# Field Sampling and Testing Plan

## Remedial Design Combe Fill South Landfill

State of New Jersey  
Department of Environmental Protection

Correspondence Regarding Comments on Field Sampling and Testing Plan

Figure 7

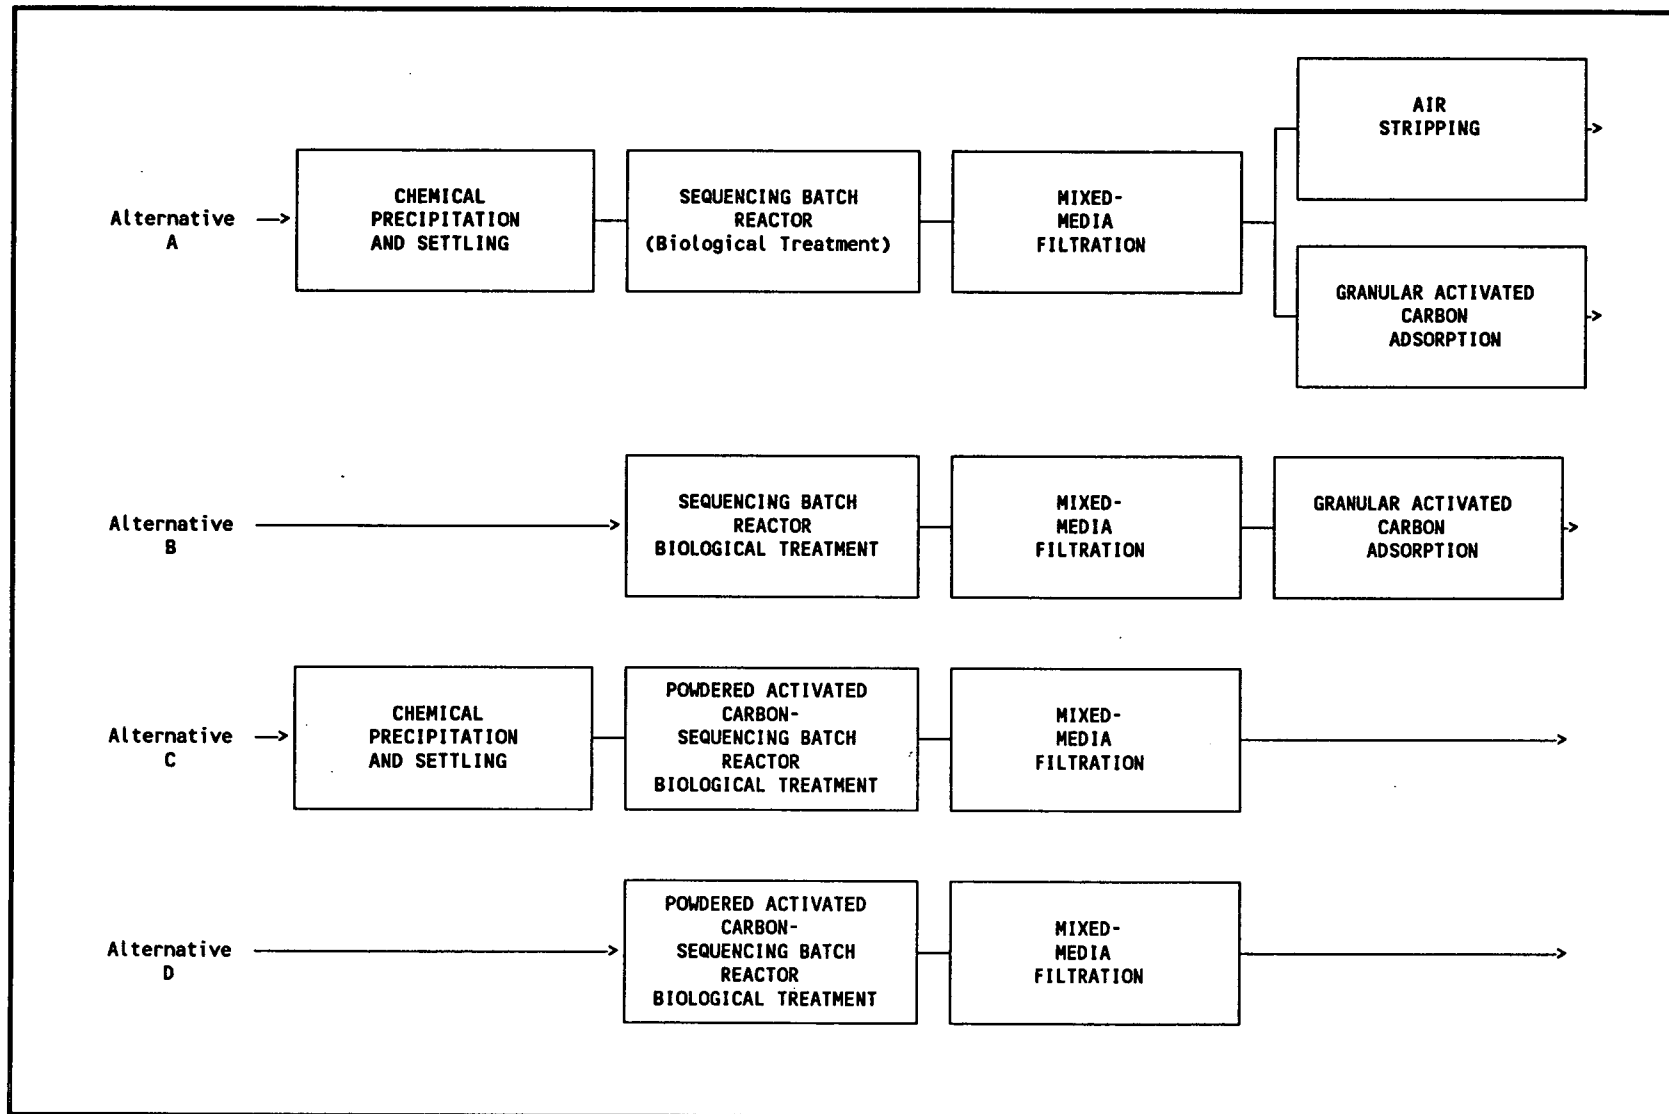
4. P. 6-7, para. 3 - Four different treatment alternatives are proposed. Only two of the alternatives include treatment by granular activated carbon units and two don't. An air stripping treatability study is proposed for one of the alternatives which already includes activated carbon. This should also be considered for one of the alternatives that will not use the activated carbon. The air stripper was not illustrated in Figure 7 - it should be included.
